## Section 3

## **Public Agency Comments**

Email submitted from: /pore/parkmgmt/planning\_giacomini\_wrp\_eiseir\_draft\_2006.htm

The California Coastal Commission received on December 19, 2006, a copy of the electronic version of the November 2006 Giacomini Wetlands Restoration Project DEIS/EIR. Commission staff comments on the document will be submitted to the NPS prior to the February 14, 2007, comment deadline. Comments will focus on relevant Coastal Act policies and jurisdictional issues (given the statement on Page 17 of the document that "... as this is a joint federal and state project, it must comply with all applicable state and local legislation on state- and county-owned lands.").

Photographed January 29, 2007 by Louis Jaffe.

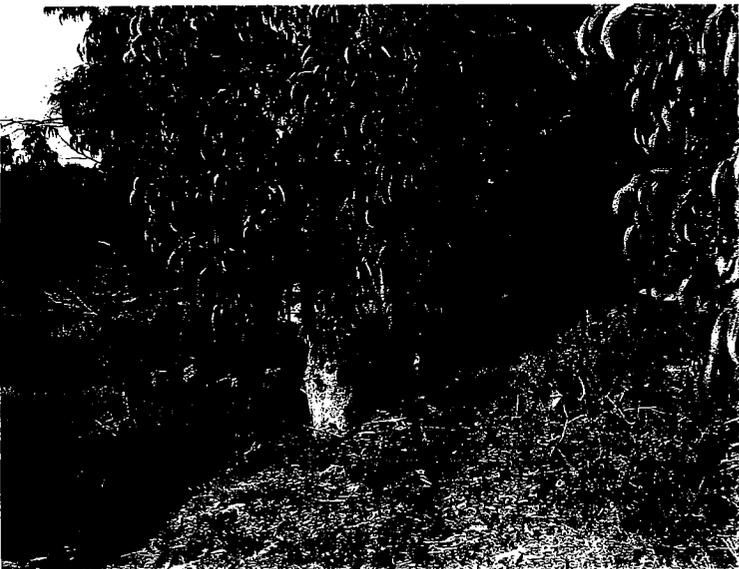
Giacomini Wetlands restoration area:  
Invasive non-native vegetation on Tomasini  
Creek levee and historic railroad grade, adjacent  
to Point Reyes Mesa Bluff, off Overlook Road  
(near boundary of Martinelli Ranch).

Eucalyptus trees on levee, railroad grade, and adjacent private property.

Recently fallen sapling on bank of slough. Larger tree in background  
fell across slough, bridging from east bank to levee.

Closeup of eucalyptus on levee. High tide in the slough inundates  
the base of the tree.

Giacomini Wetland Restoration Project

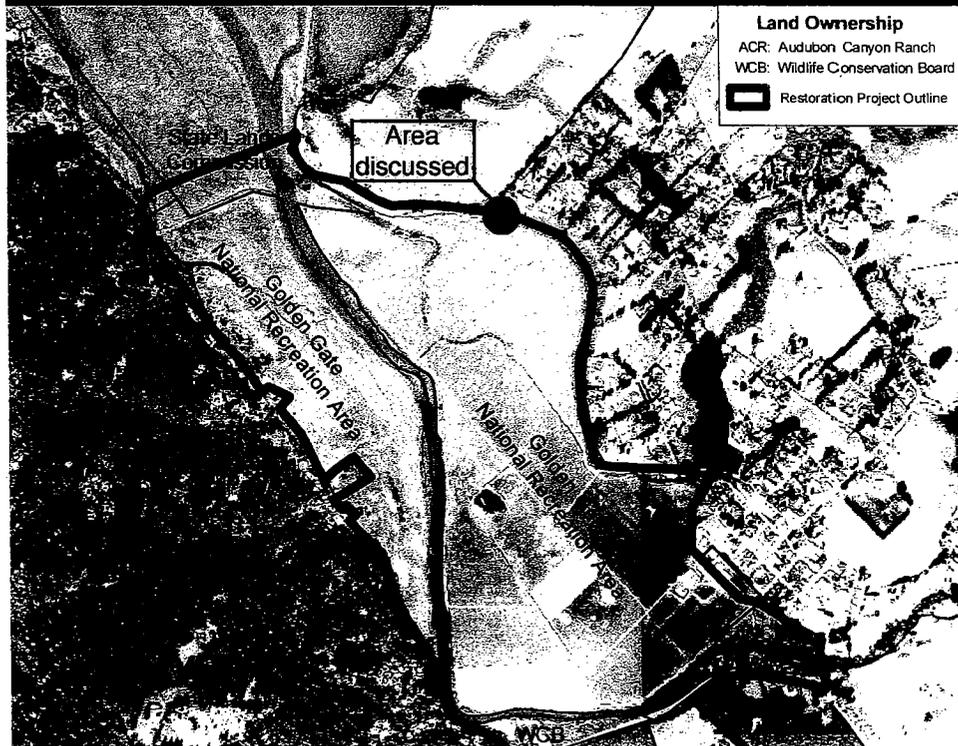
Detail from Project Area map, Giacomini Wetlands project EIS / EIR with emphasis added to pinpoint area of invasive plants on berm and historic railroad grade
